**DRAFT AMENDMENT NO. 12**  
**(RUSSELL)**  
**OF THE NATIONAL CAPITAL PLAN**

Report of the Joint Standing Committee on the  
National Capital and External Territories

May 1995

Figure 3.2 Blamey Square masterplan

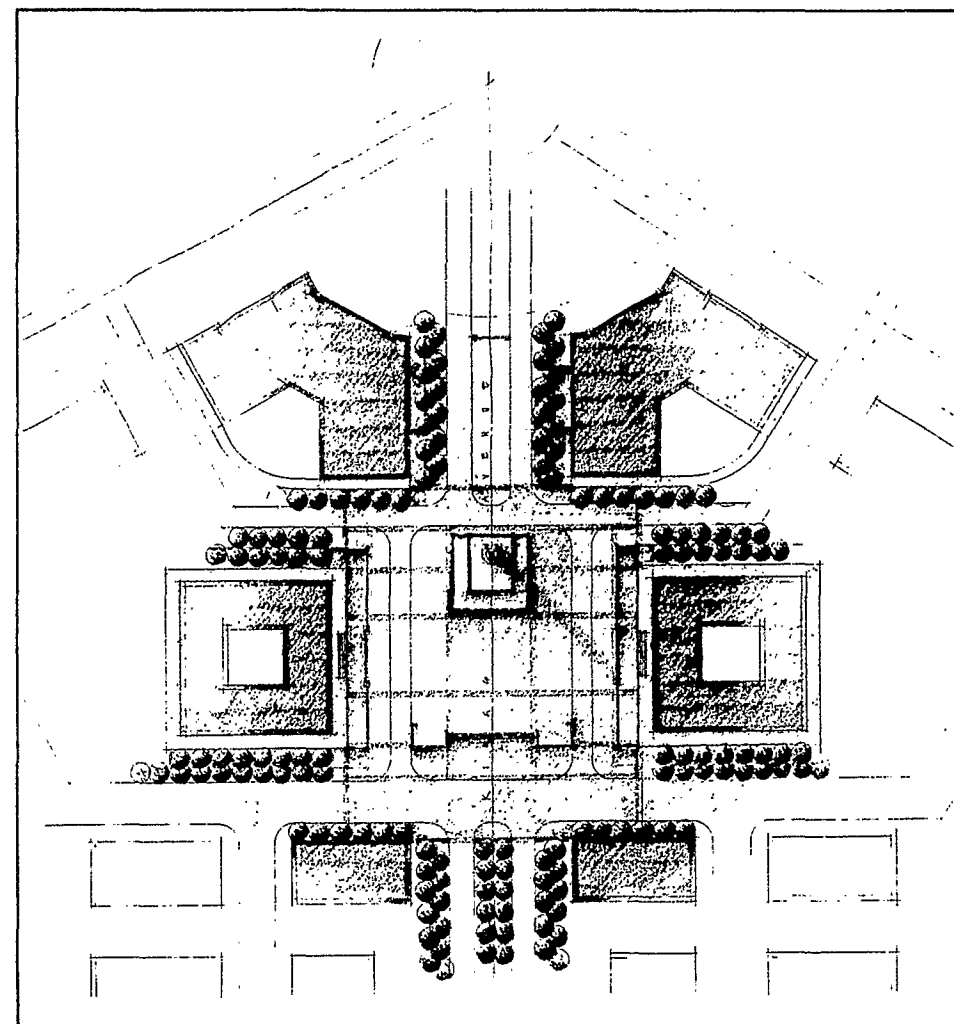
**3.15** The Committee believes that the need for traffic management techniques removes the utility (other than for visual completion) of a costly extension to Kings Avenue to the apex of the National Triangle through Blamey Square. The question is: why build a road through Blamey Square which may require the introduction of traffic management techniques to limit its function as a through road and necessitate its closure on a fairly regular basis?

3.26 There is no specific mention of Blamey Square in Draft Amendment No. 12. Further, there is no indication of the likely shape and width of either Blamey Square or the proposed road if the Kings Avenue extension proceeds through Blamey Square to the roundabout at the apex of the National Triangle. This lack of detail constrained the Committee's examination and evaluation of the proposal. The omission of specific detail about the proposal seems to be a contributing factor in the diversity of views over the likely impact of the proposed road network on Blamey Square.

3.30 The Committee does not accept the NCPA's argument for not providing better information about its proposals for Blamey Square. More explicit details about the proposed carriageways and traffic control measures would have greatly assisted this Committee in its consideration of the proposal to extend Kings Avenue. As mentioned in chapter 2, this Committee may give consideration at a later date to the level of detail that is required by the Parliament and the public in order to make a reasoned assessment of proposals to change the National Capital Plan.

Figure 3.3 Archaeological sites

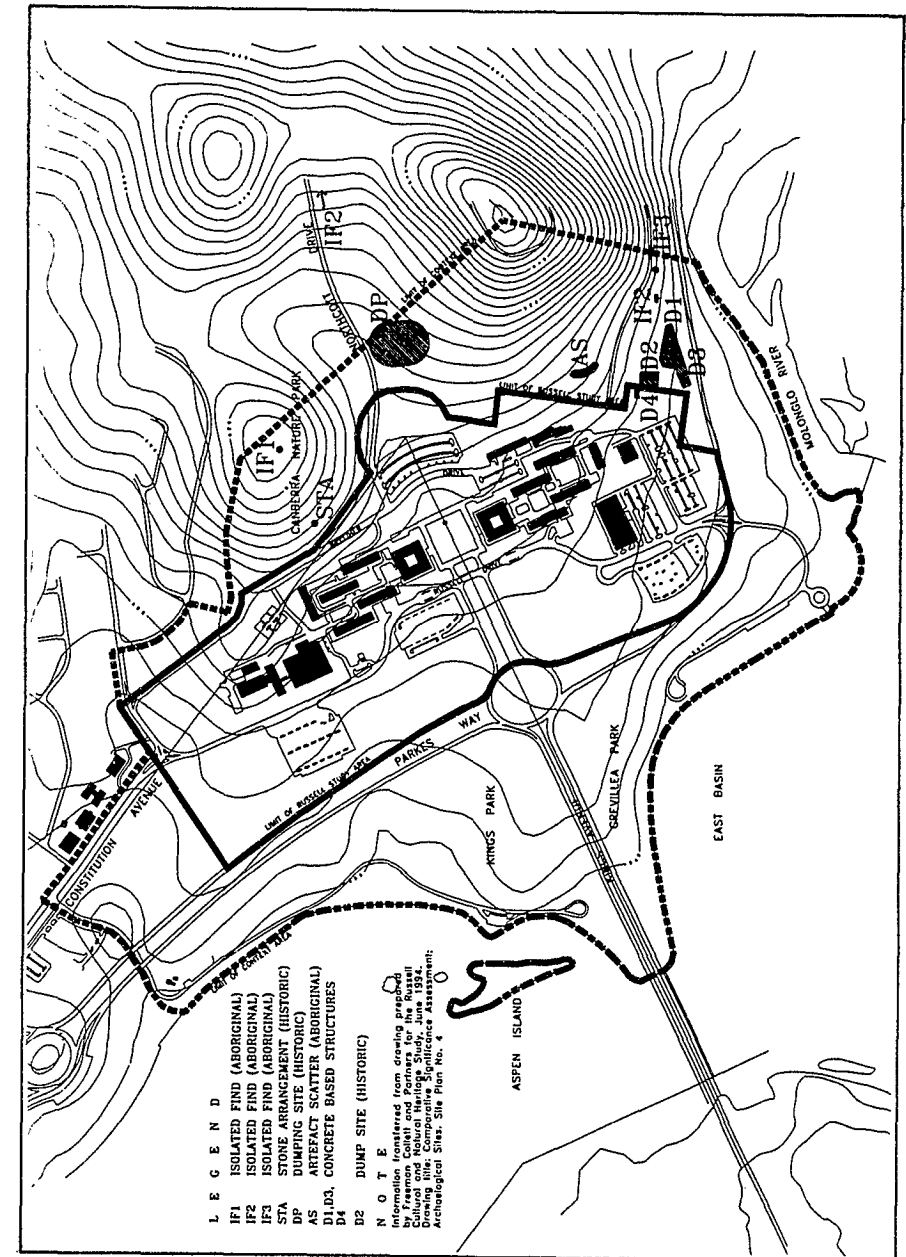
3.67 The Committee had some reservations about the proposed excavation because it seems to be close to a stone arrangement which was noted in the *Draft Russell Master Plan Background Report* (1994) (the Background Report) (see figure 3.3).<sup>44</sup> Freeman Collett and Partners assessed the site and reported to the NCPA that the site probably relates to the workers camp associated with the original construction of the Russell complex. In the consultant's opinion the site has a very low significance rating.<sup>45</sup> Defence indicated that there was no reference to the site in its heritage records.<sup>46</sup>

Figure 3.6 Russell pedestrian masterplan

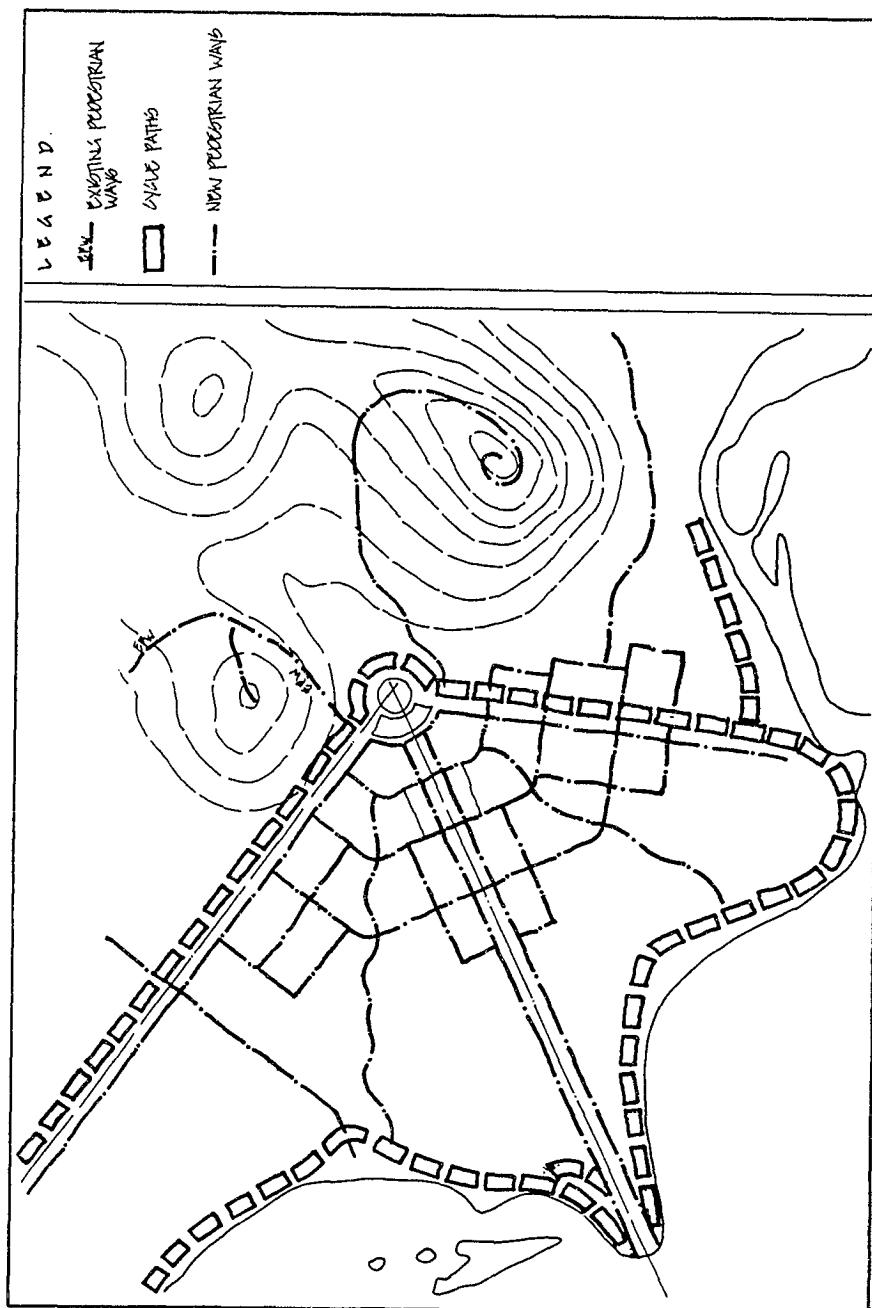
**3.101** The Committee notes that the pedestrian and cycle paths suggested in figure 3.6 do not include provision for safe pedestrian and cycle access across Parkes Way to the lake foreshore. The Committee believes that safe access across Parkes Way is of paramount importance to the concept of a coherent pedestrian and cycle network.

Figure 4.4 Russell transport masterplan

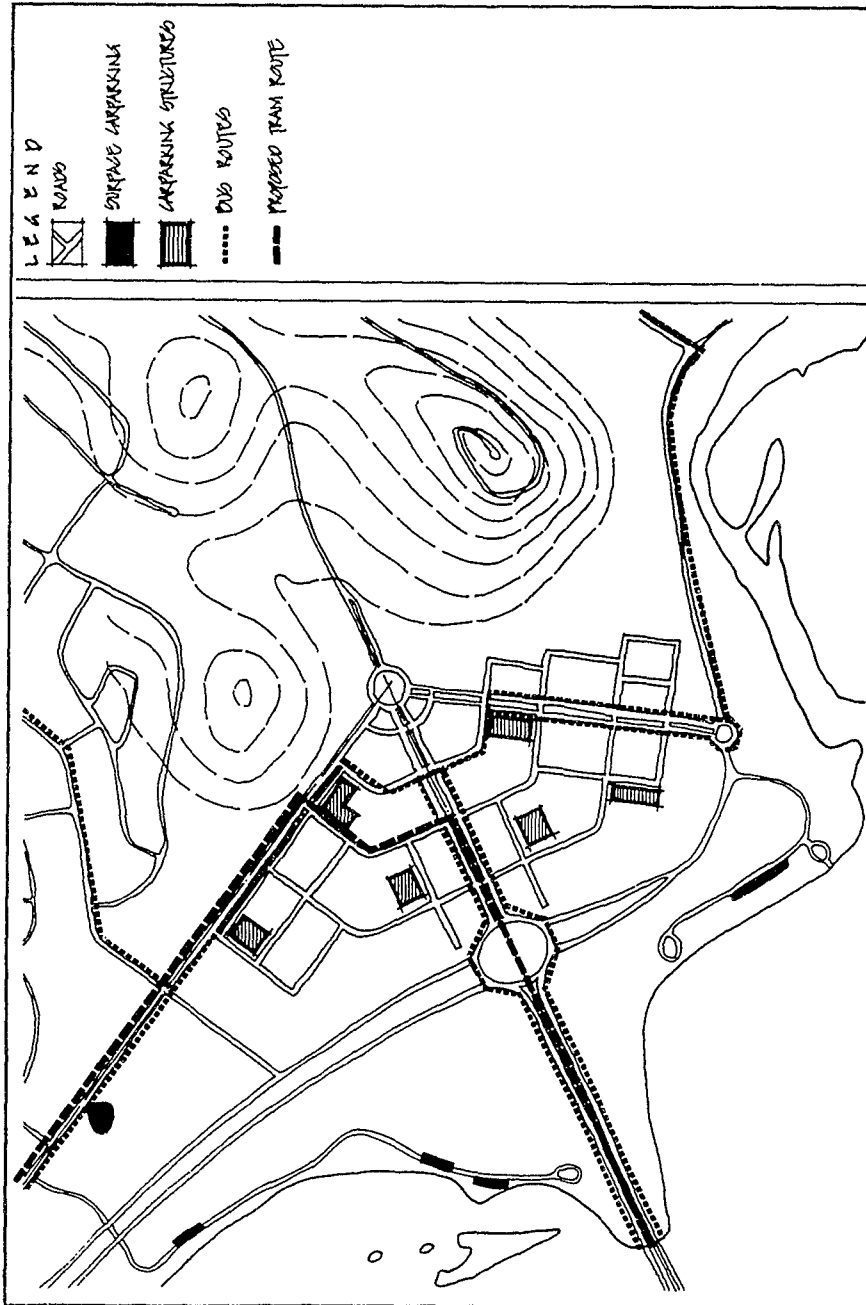
4.62 One of the parking structures shown in figure 4.4 is shown as 'L-shape building'. The Committee noted that the same building is shown in figure 4.2 as being rectangular in shape. Such inconsistency between the documentation provided by the NCPA and Defence adds to the Committee's difficulty in assessing the implications of Draft Amendment No. 12.

Figure 4.9 Location of the Duntroon Dairy

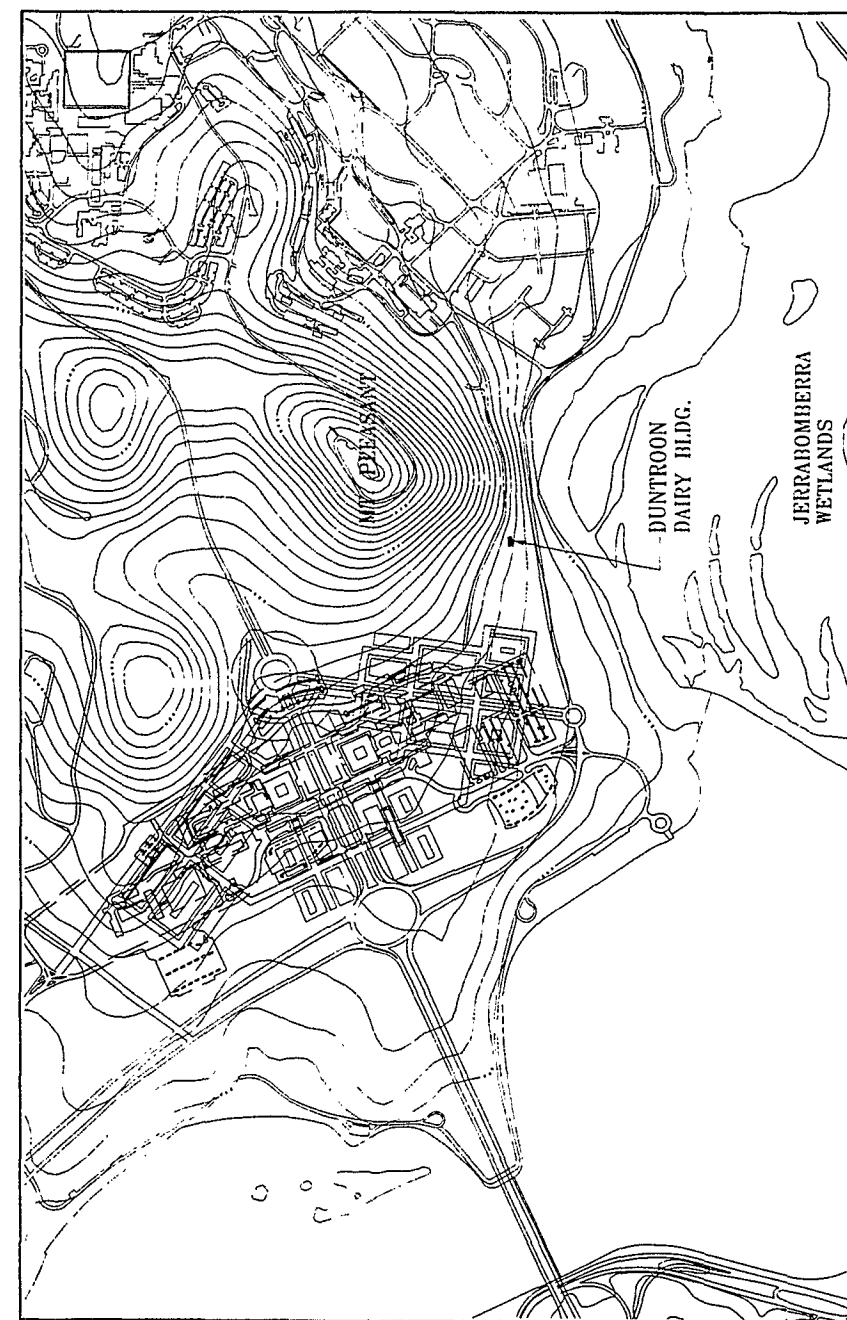
4.148 The Heritage Council expressed concern that 'There appears to be a lack of clear analysis and justification for the heritage assessments made'.<sup>106</sup> Of particular concern was the perceived failure of the NCPA to consider the likely impact of traffic and overflow car parking on important heritage buildings such as the Duntroon Dairy, Blundell's Cottage and St John the Baptist Anglican Church.<sup>107</sup>

4.149 In response, the NCPA prepared a map which it believes demonstrates that the road proposals '...will have no direct impact on Duntroon Dairy or Blundell's Cottage', (see figure 4.9). With regard to St Johns Church in Reid, the NCPA maintains that '...there is no proposal to change the existing road reservation boundary on the northern side of Constitution Avenue'.<sup>108</sup>

*Diagram 1 : Russell Indicative Layout*

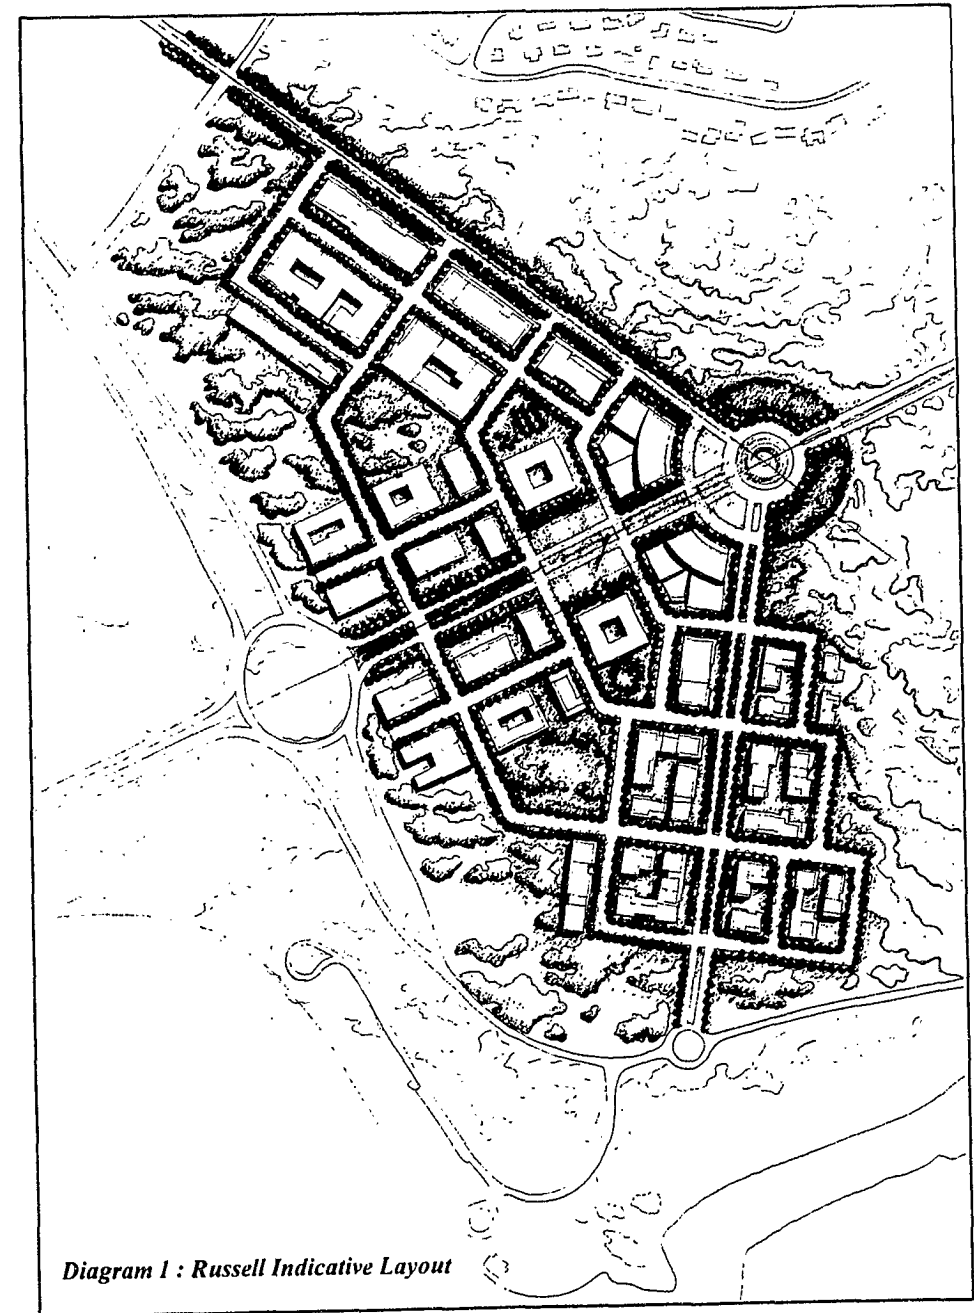
2.48 For example, the Committee is concerned about discrepancies which occurred in information supplied by the NCPA and Defence about the proposed location of buildings RN1 and RN2. According to the NCPA's Russell Indicative Layout diagram there is a buffer zone located between these buildings and the roundabout (see appendix B). However, drawings of the project stages submitted by Defence to the Parliamentary Standing Committee on Public Works do not show this buffer zone.<sup>22</sup> The Committee appreciates that Defence is not responsible for the construction of the roundabout at the apex of the National Triangle.

Heritage issues do not appear to be adequately discussed within the document. Neither of the artists' impressions at Attachment 1 [to Draft Amendment No. 12 : Proposed replacement for Figure 12] or Diagram 1 [Draft Amendment No. 12 : Russell Indicative Layout] pay attention to items of significance as recorded in the Draft Russell Master Plan Background Report.<sup>118</sup>

The Committee recommends that the proposed detailed amendment to the Indicative Layout diagram showing pedestrian and cycle routes be completed by the end of 1995. Further, the Committee recommends that the revised Indicative Layout diagram be advertised in the *Commonwealth Gazette* and in the principal daily newspaper published and circulated in the Territory as stated in the *Australian Capital Territory (Planning and Land Management) Act 1988*, for public comment before finalisation of the plan and design of pedestrian and cycle routes.
